**KAHLE WATER QUALITY BASIN IMPLEMENTATION PROJECT
STATELINE, NEVADA**

Nevada Tahoe Conservation District
400 Dorla Ct., PO Box 915
Zephyr Cove, Nevada 89448
(775) 586-1610

ITEM 2: Replace plan sheets C-3, C-4, C-5, and C-6 dated March and February 2018, respectively, with plan sheets C-3, C-4, C-5, and C-6 dated April 2018 and provided in this addendum. The revised plan sheets contain the following changes:

ADDENDUM NO. 1, Page 2 of 2

C-6

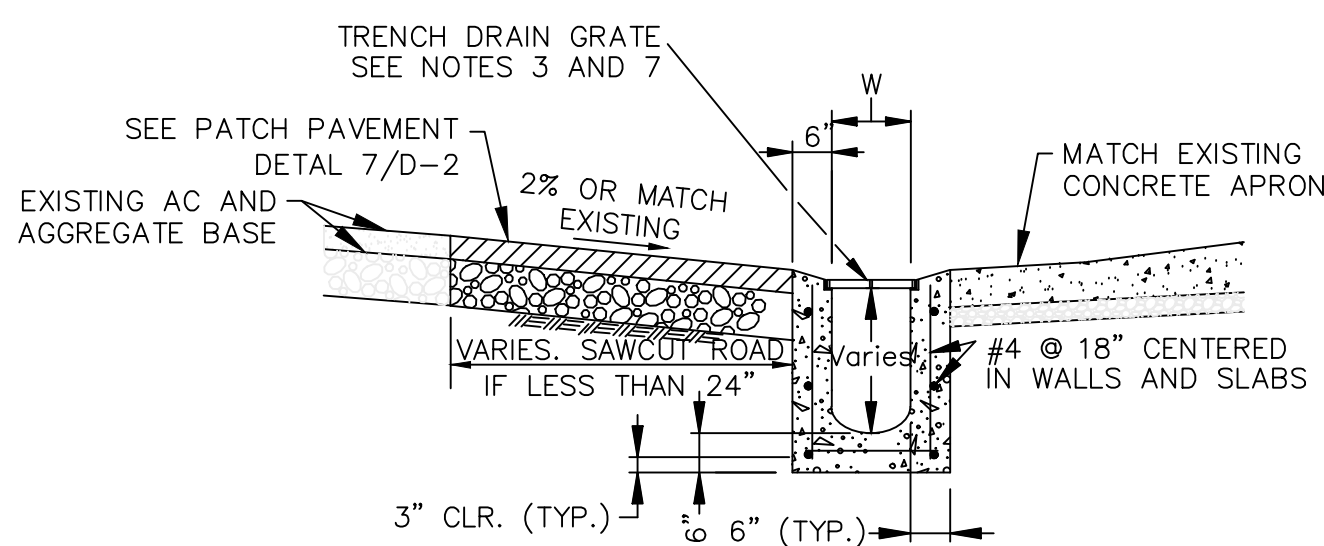
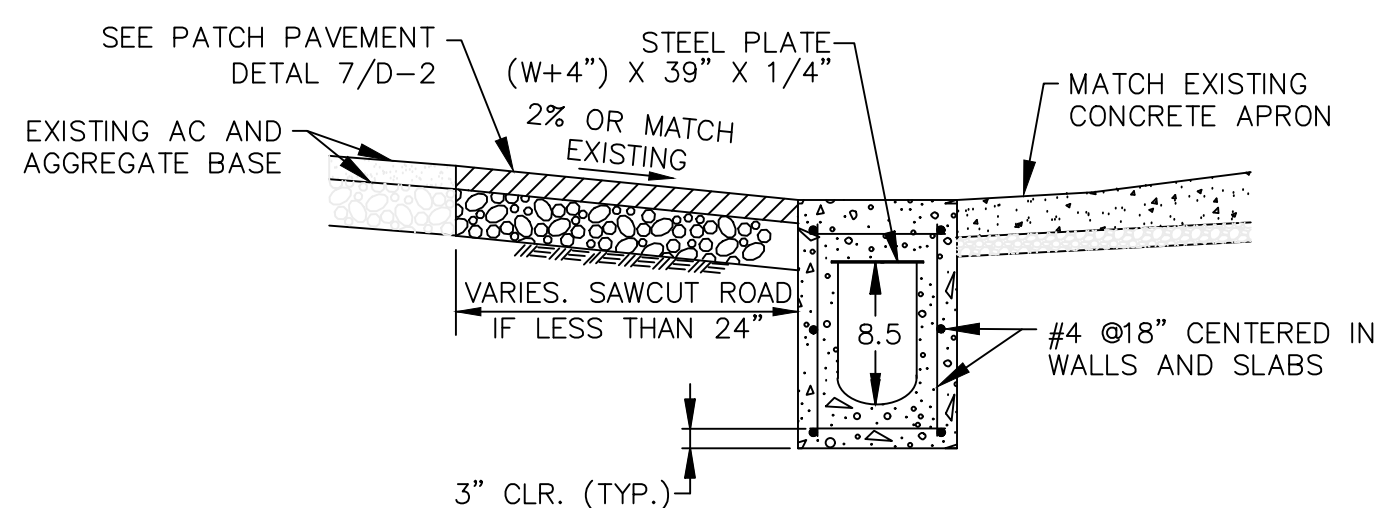
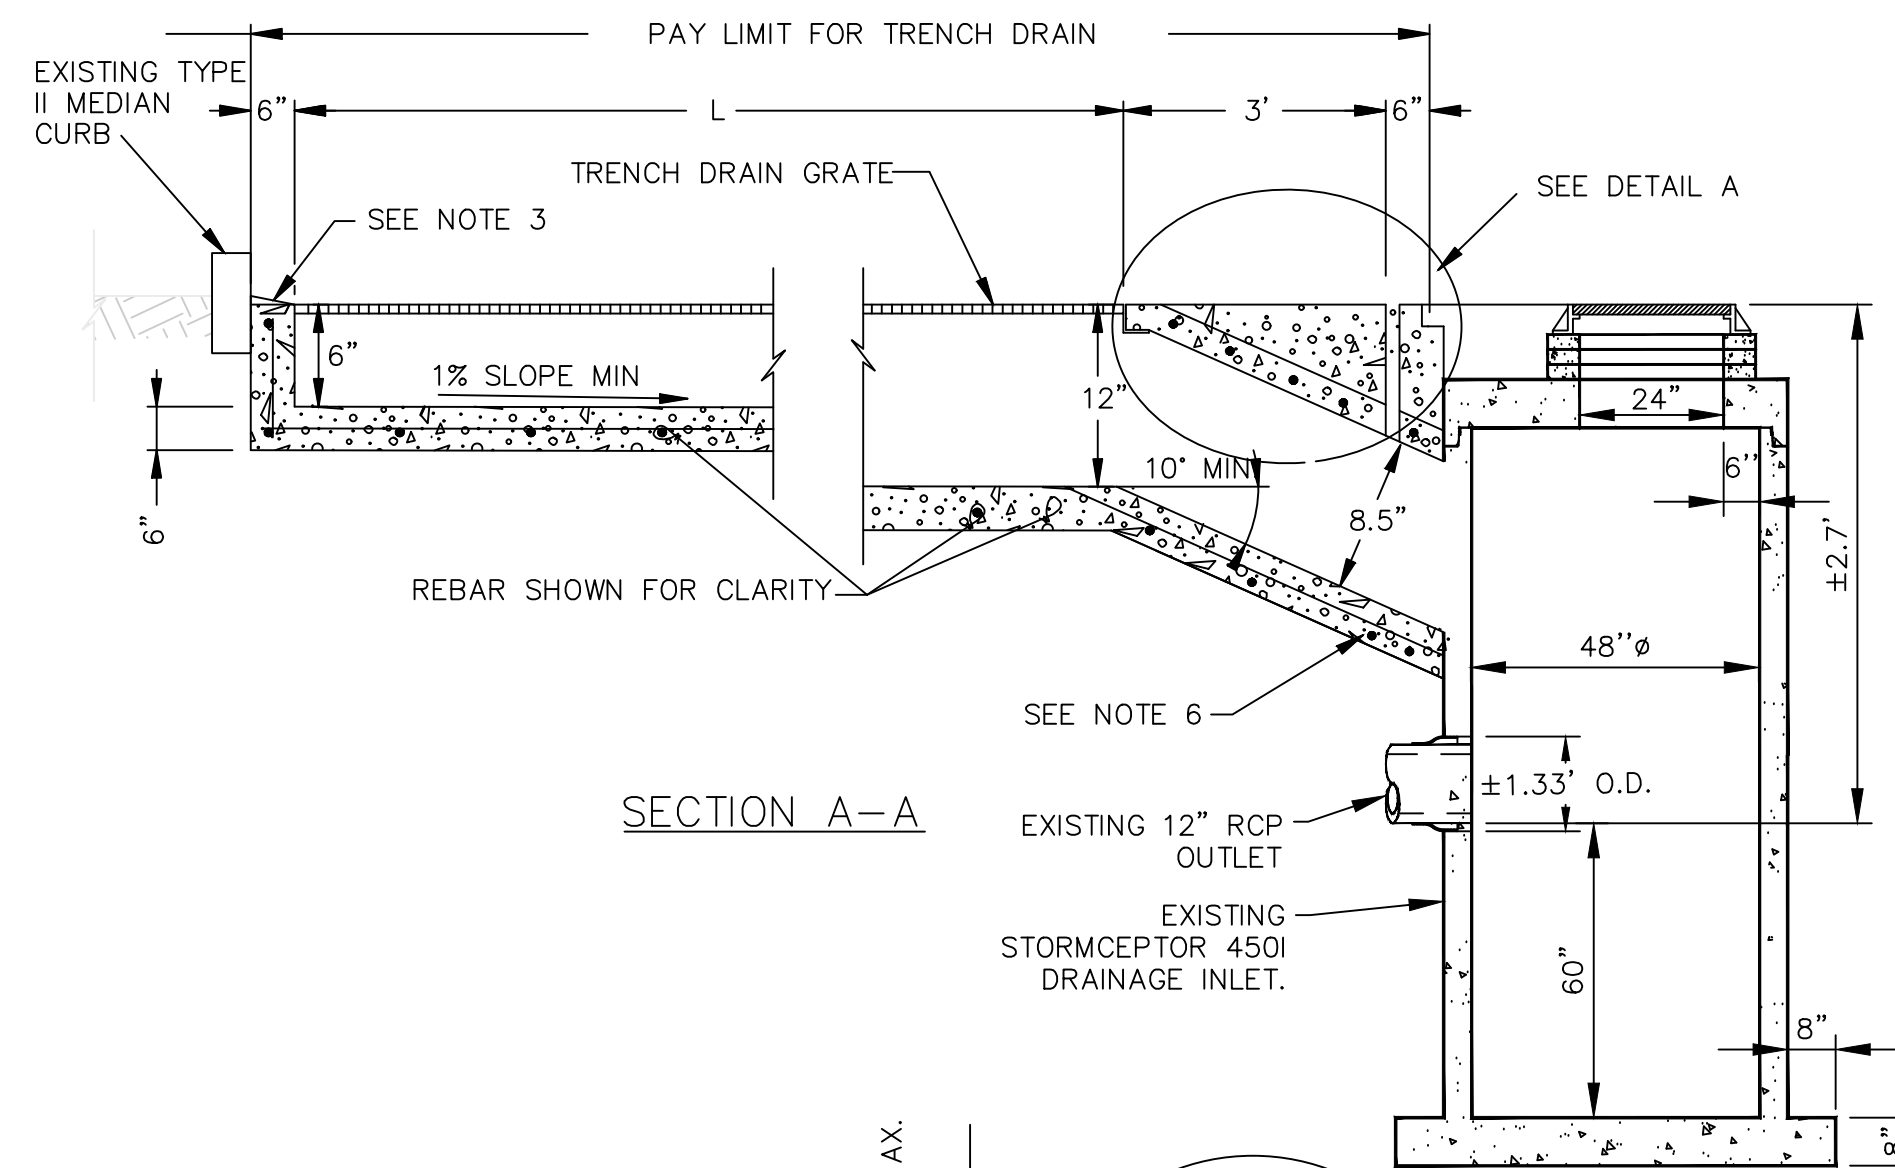
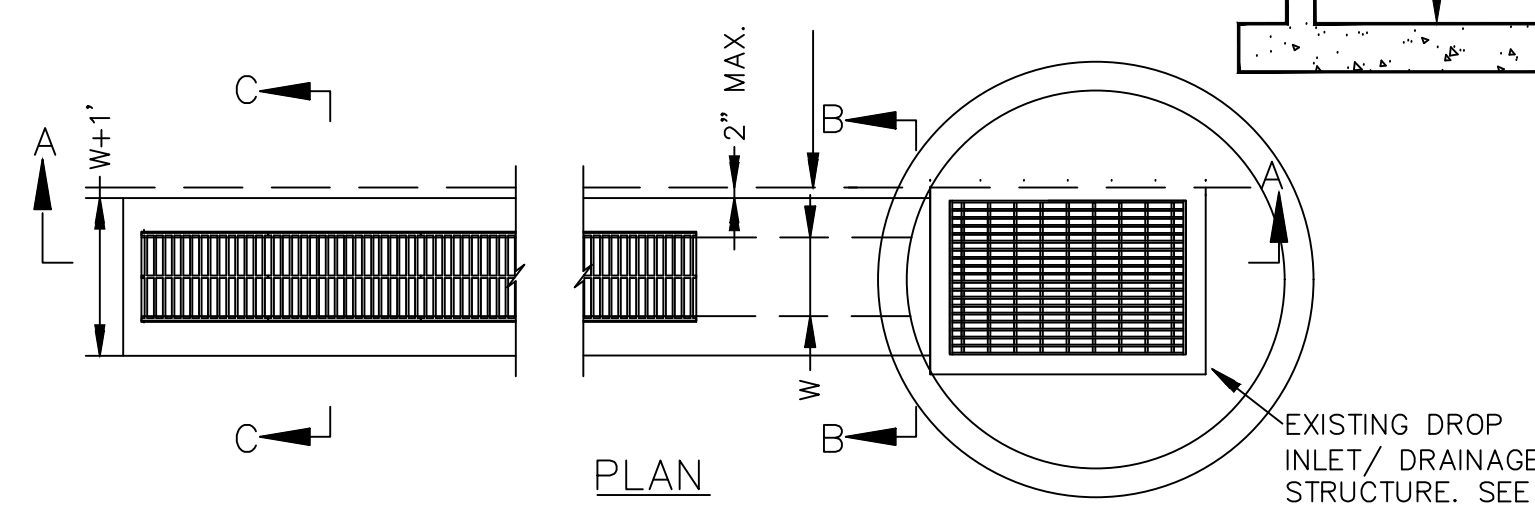
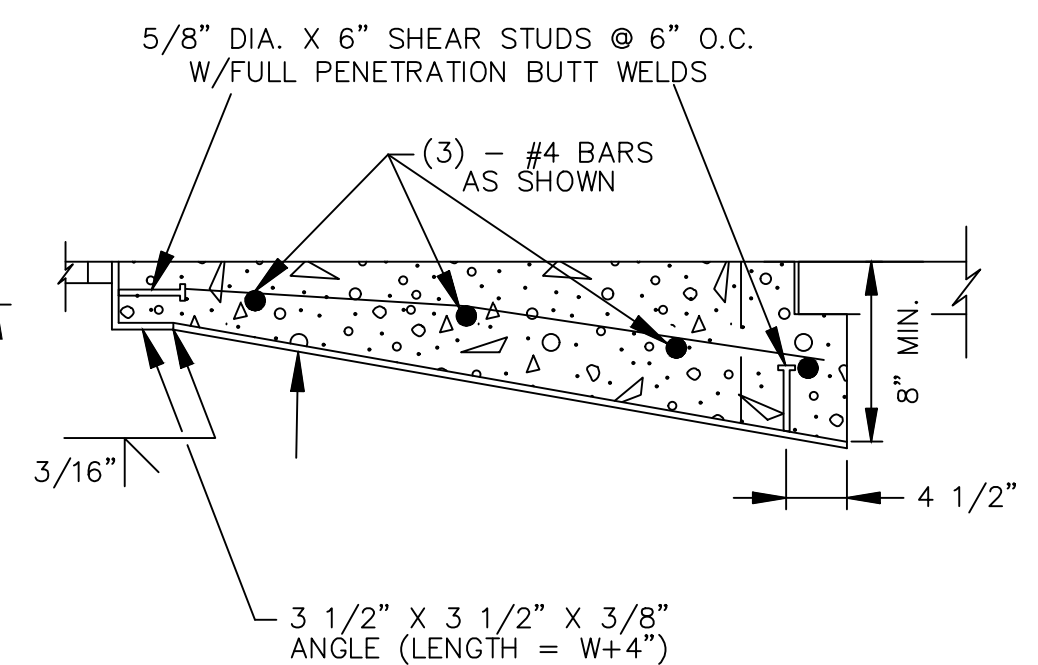
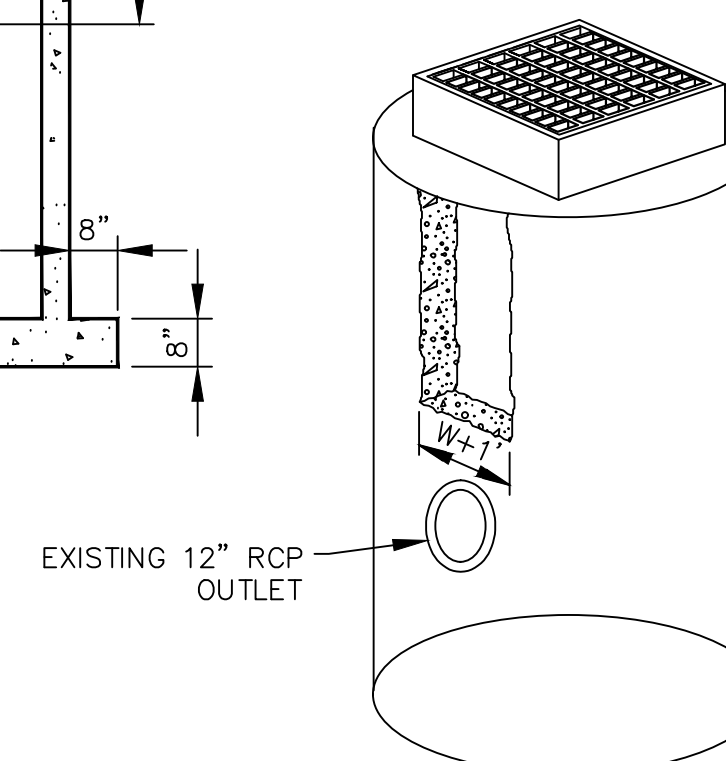
5. An existing rock basin is shown on the plans. Additional detail has been added on removal and replacement of the existing basin over the storm drain pipe alignment. This work shall be considered as part of the linear foot unit cost for bid item 21 (C-5 and C-6).

6. Additional detail is added for the inlets of the existing rock basin in plan and profile (C-5 and C-6).
7. A ±19 linear foot trench drain is called out for installation and connection to the existing Stormceptor 450i drainage inlet. This is a bid alternate item.

8. The limits of the saw cut for the parking lot have increased to account for the installation of the proposed trench drain. This is a bid alternate item.
